October 4th, 2016
Cedar Plains Family Medicine
Hickman, Nebraska

ADDENDUM 1

Sheet A1.1

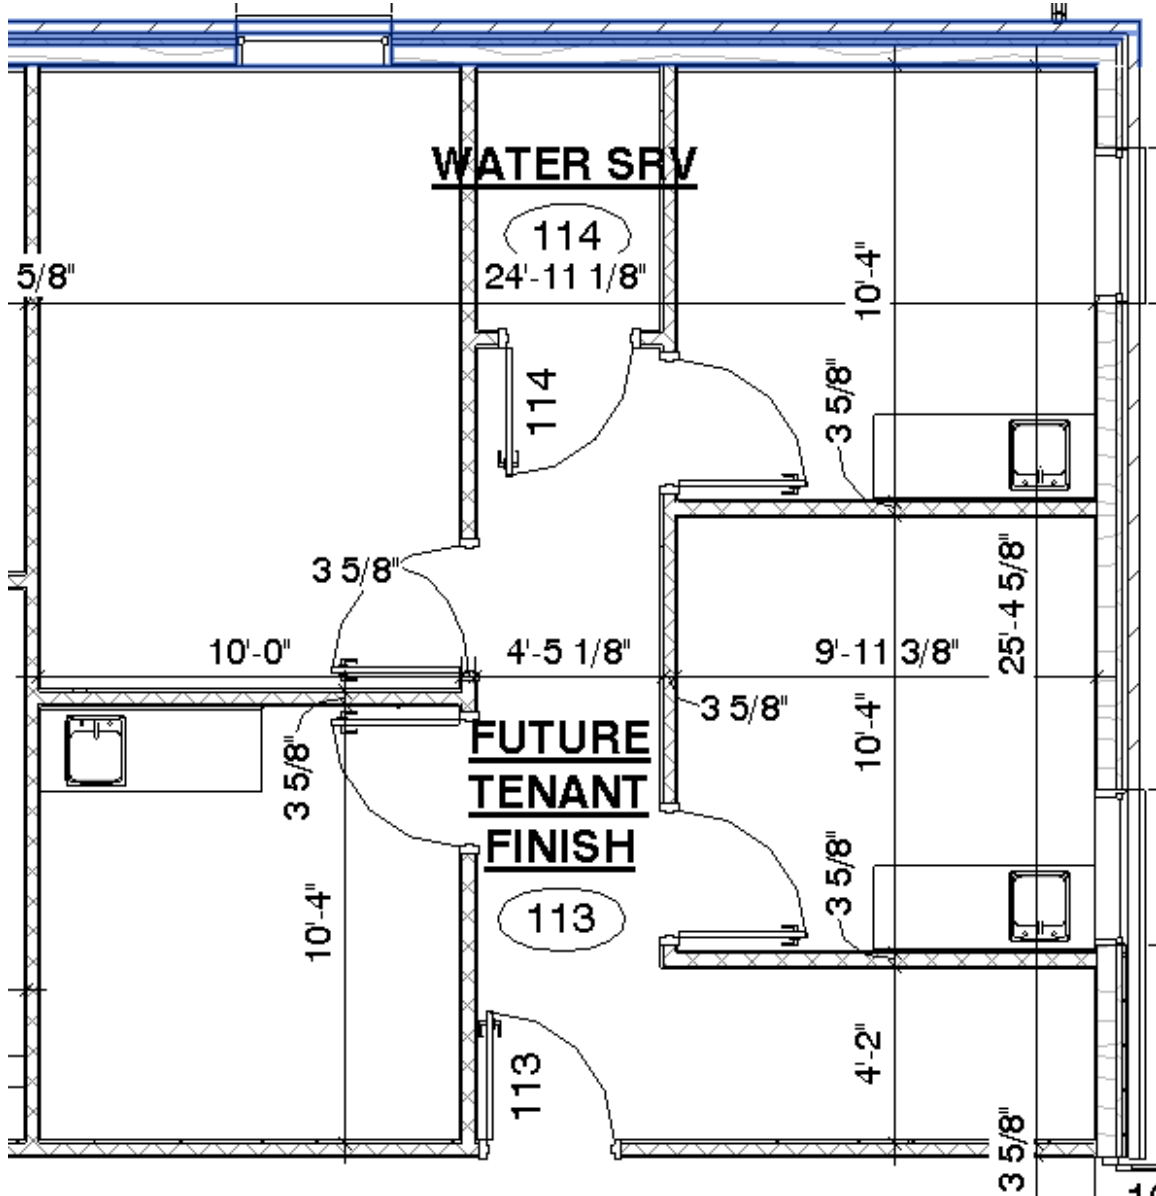
A. Future Tenant Finish 113 – See attached plan for future room layout
